PRODUCT/PROCESS CHANGE NOTICE (PCN)

PCN #: A0705-01 DATE: 6/11/2007 Product Affected: Ceramic DIP, Sidebrazed and Topbrazed of 28 leads or more (Refer to Att. II for affected part numbers) Date Effective: 9/11/2007	MEANS OF DISTINGUISHING CHANGED DEVICES: <input type="checkbox"/> Product Mark <input type="checkbox"/> Back Mark <input type="checkbox"/> Date Code <input checked="" type="checkbox"/> Other Shipment starting from 9/11/2007
---	---

ATTACHMENT I - PCN #: A0705-01

Figure 1: Existing material - Silicon bump

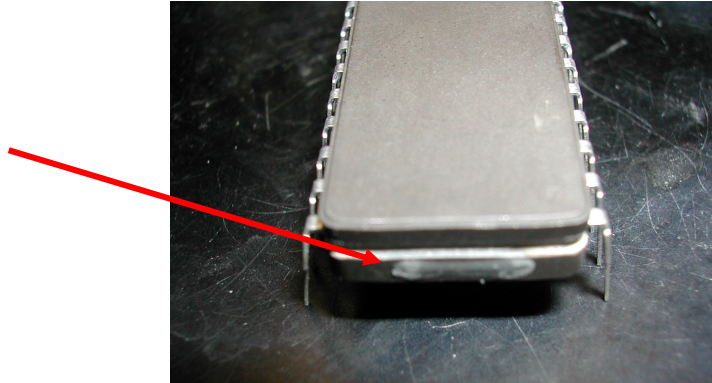
PCN Type: Assembly Material Change
Data Sheet Change: None
Detail Of Change: This notification is to advise our customers that there will be a change of material from silicon bump to bumper tape, which is applied at the package end (opposite pin 1) to prevent package crack or chip as a result of knocking between units.
